**DRAINAGE LETTER
FOR
19580 FOUR WINDS WAY**

FEBRUARY 2022

PCD FILE NO's:
CDR225

19584 FOUR WINDS WAY
 MONUMENT, CO 80132
PROPOSED DRAINAGE PLAN

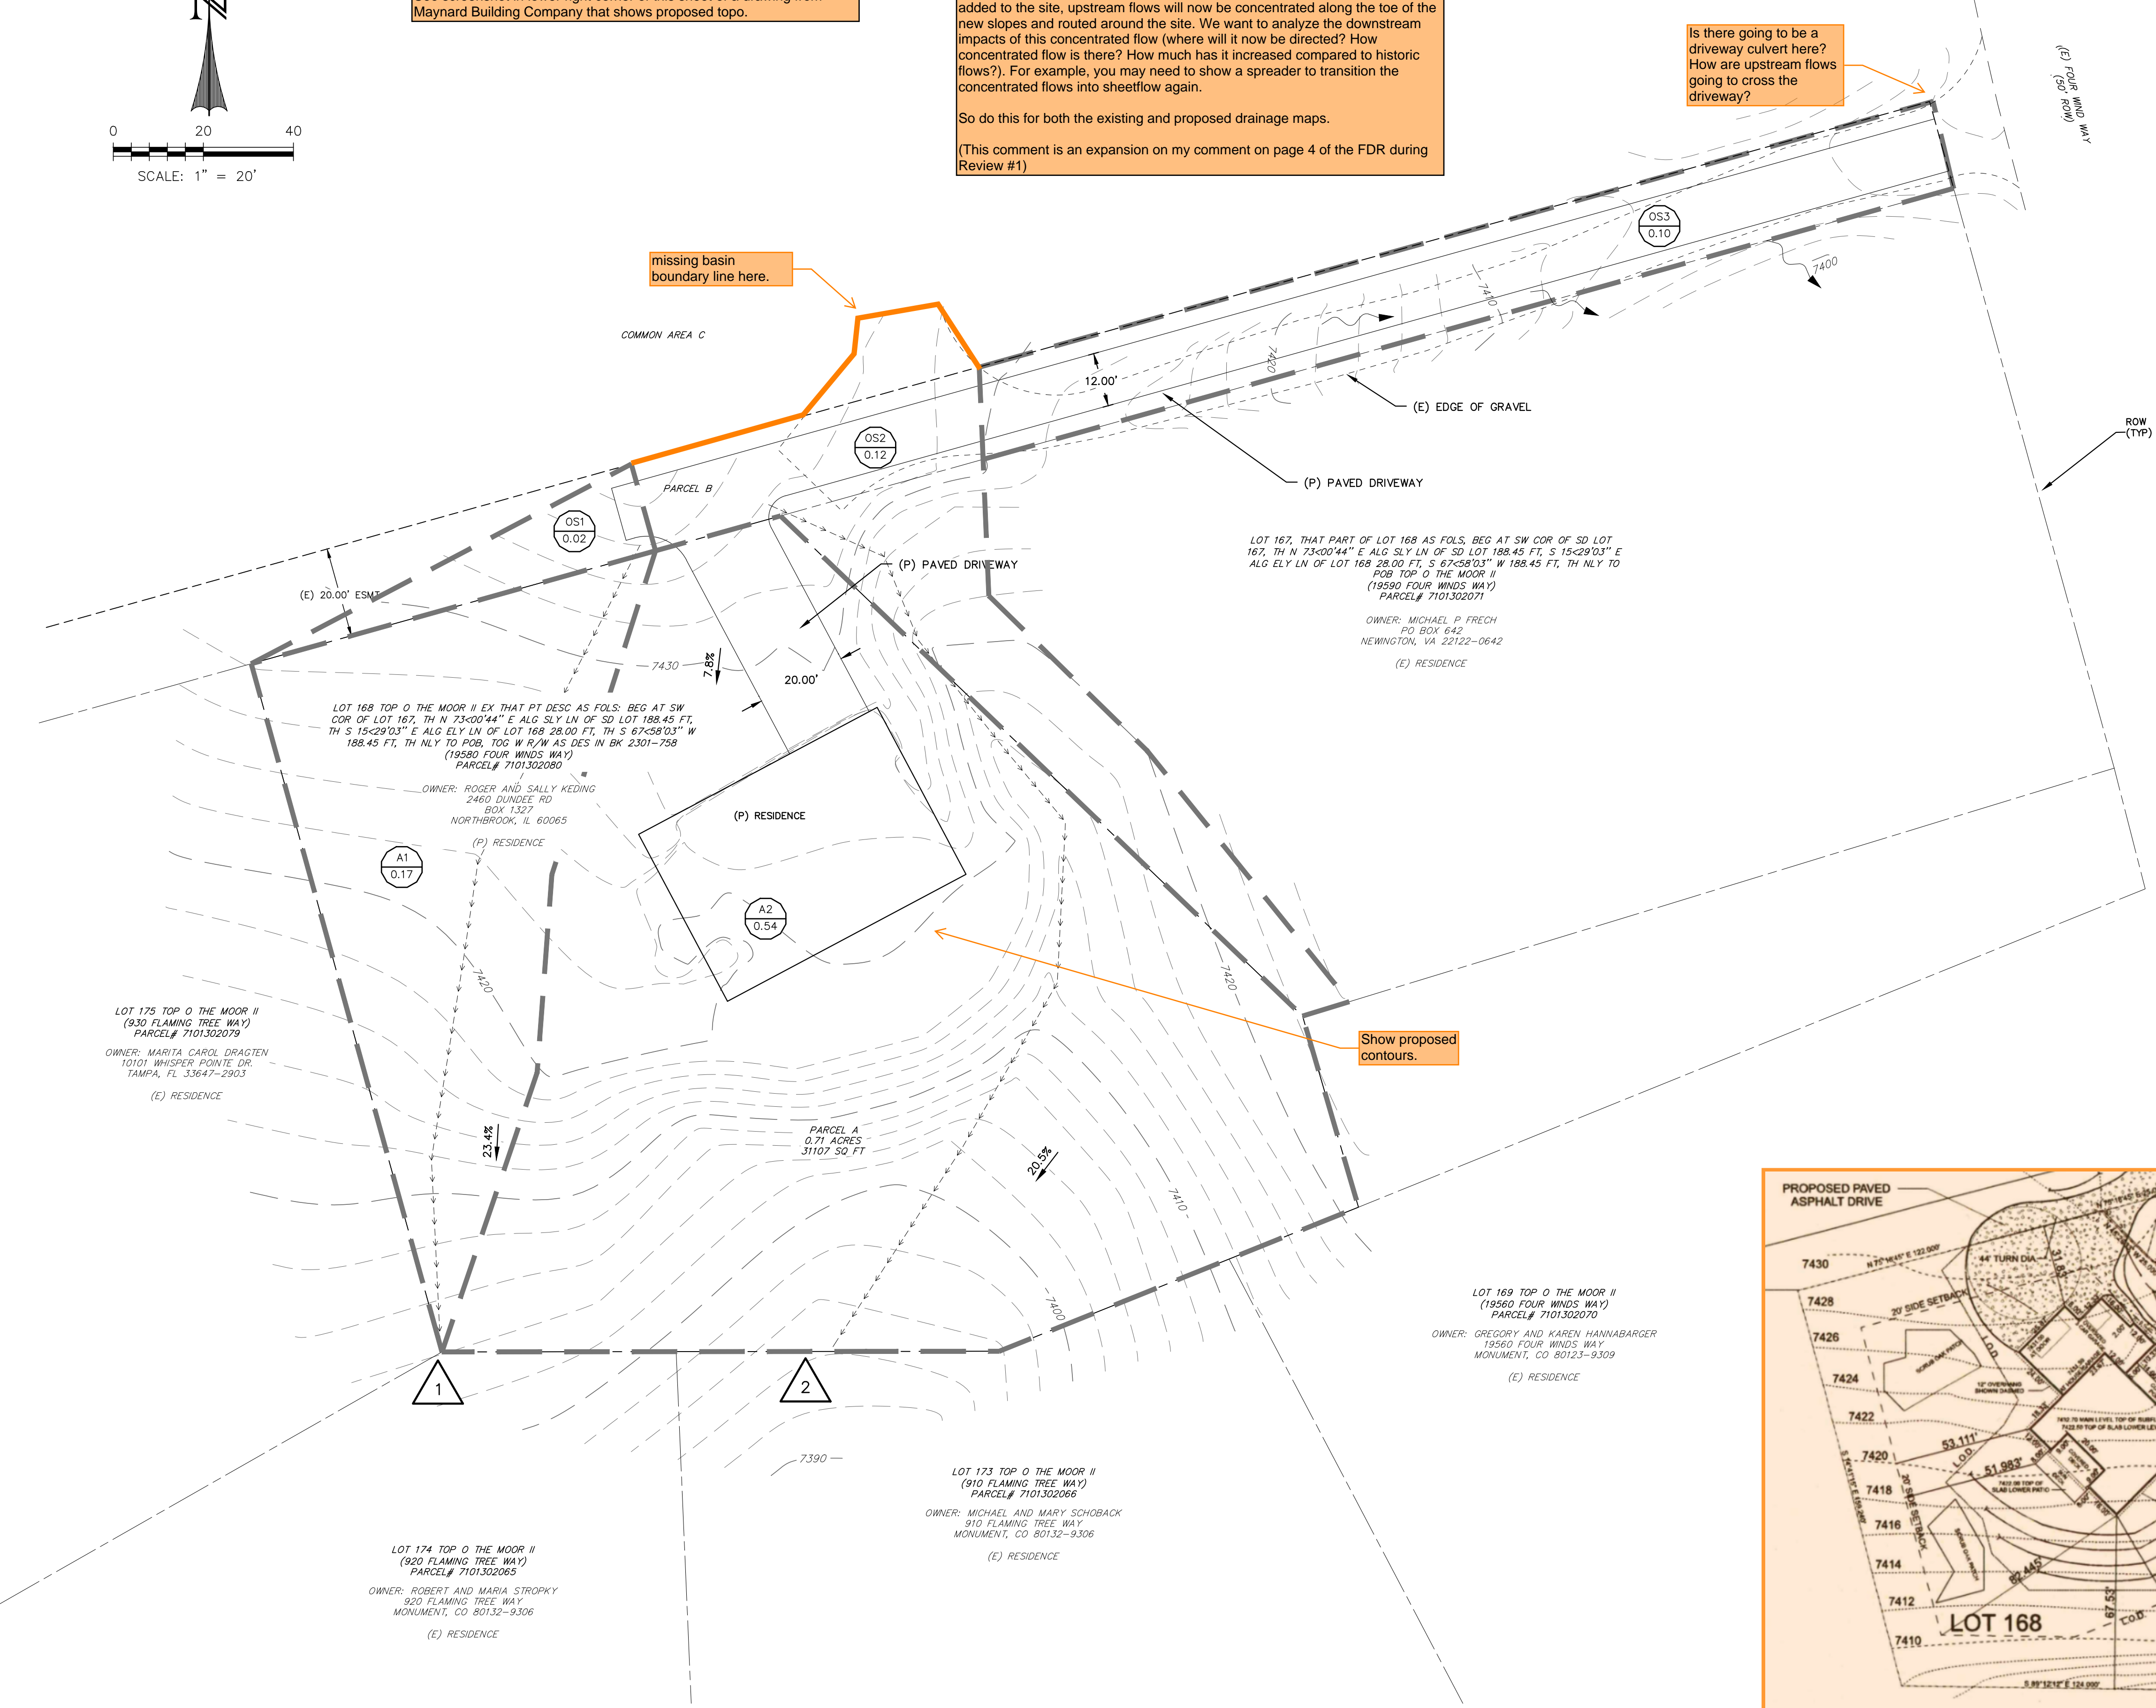
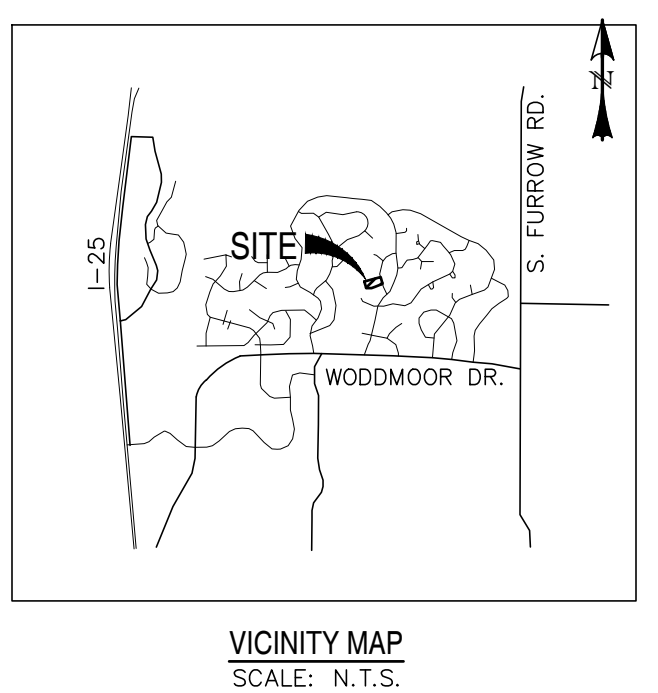
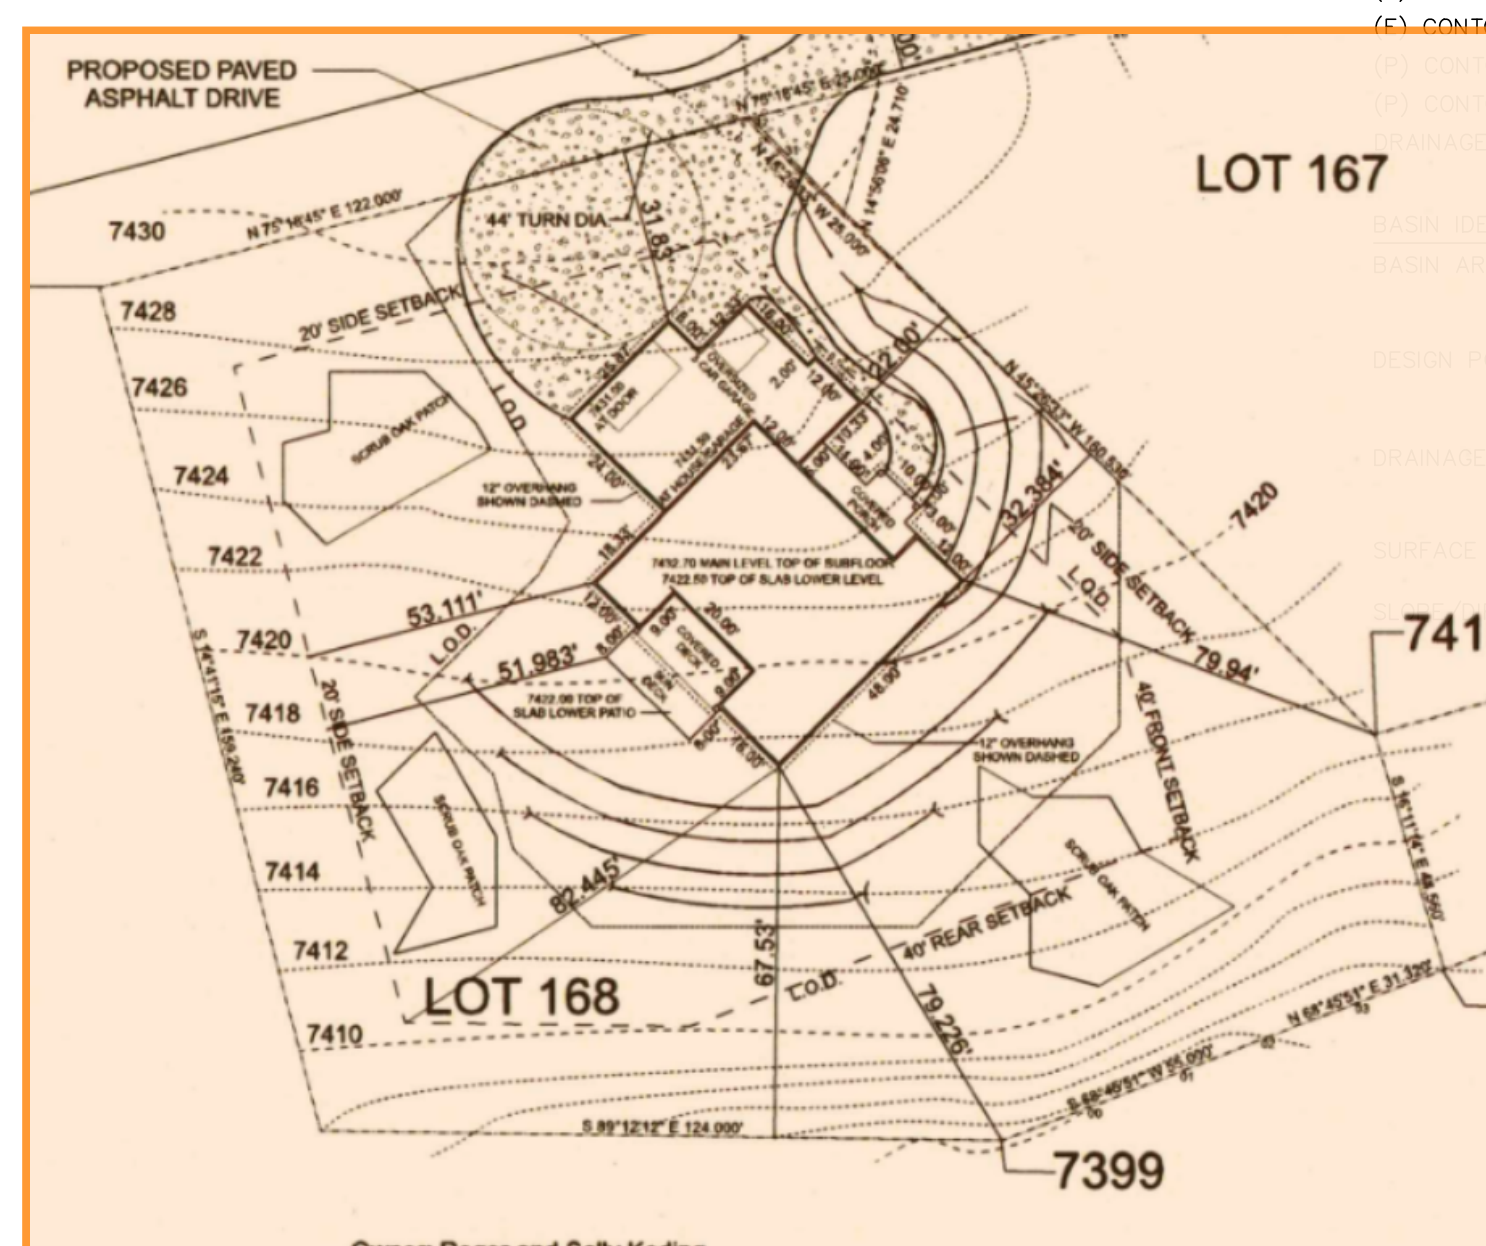
Unresolved comments from Review #1:
 Notate date and source of topo survey.
 This map should show proposed topo, which should include a flat pad around the house, for example. This does not appear to show final topo. See screenshot in lower right corner of this sheet of a drawing from Maynard Building Company that shows proposed topo.

We require all developments to show areas of upstream basins that are tributary to the site. Use publicly available topo to generate approximate areas for the upstream basins, so flows can be estimated. Since so much fill was added to the site, upstream flows will now be concentrated along the toe of the new slopes and routed around the site. We want to analyze the downstream impacts of this concentrated flow (where will it now be directed? How concentrated flow is there? How much has it increased compared to historic flows?). For example, you may need to show a spreader to transition the concentrated flows into sheetflow again.
 So do this for both the existing and proposed drainage maps.
 (This comment is an expansion on my comment on page 4 of the FDR during Review #1)

Is there going to be a driveway culvert here? How are upstream flows going to cross the driveway?
